**Dominion Nuclear Connecticut, Inc.
Millstone Power Station Unit 3**

Millstone Power Station Unit 3 Order EA-12-051 Compliance Requirements Summary

**Order EA-12-051 Response to SFPI RAIs
and Safety Evaluation Review Item 11**

Spent Fuel Pool Indication (SPFI) RAIs 2, 7, 8, 9, 10, 11, 13, and 14

Millstone Power Station Unit 3 SFP Level Instrumentation Plan View
 (EL. 52'-4")

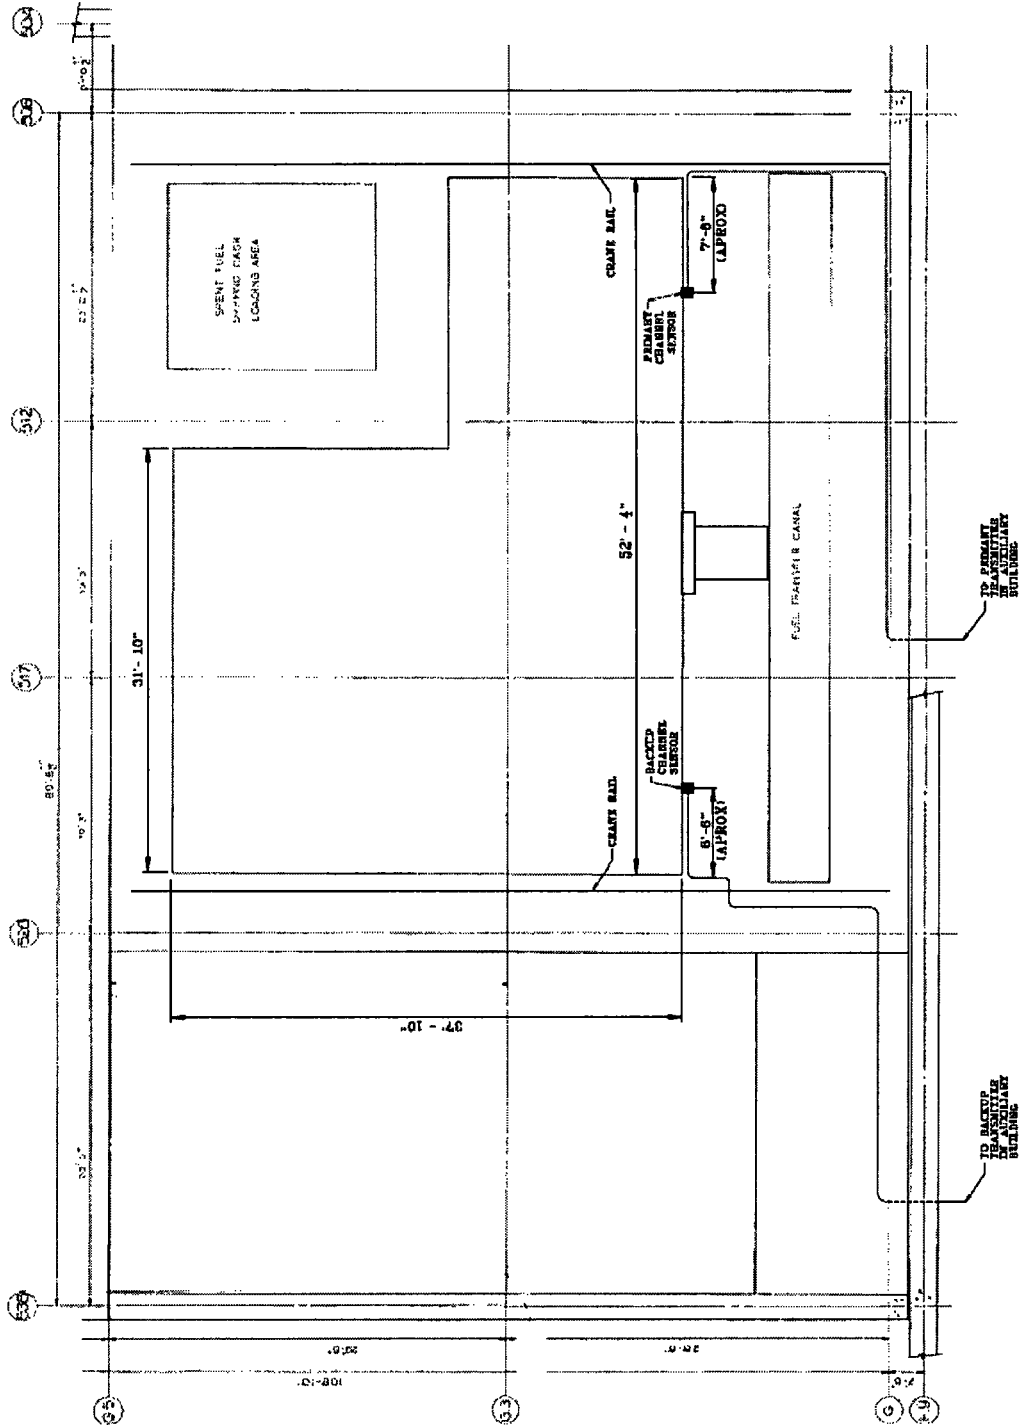
SFPI RAI No. 1

Please provide a clearly labeled sketch or marked-up plant drawing of the plan view of the SFP area, depicting the SFP inside dimensions, the planned locations/placement of the primary and back-up SFP level sensor, and the proposed routing of the cables that will extend from these sensors toward the location of the read-out/display device.

A plan view sketch of the Millstone Power Station Unit 3 (MPS3) Spent Fuel Pool (SFP) area is provided in the figure below. The sketch depicts the MPS3 SFP inside dimensions, the planned locations/placement of the primary and back-up channel sensors, and the proposed cable routing that extend the sensors toward the location of the electronics.
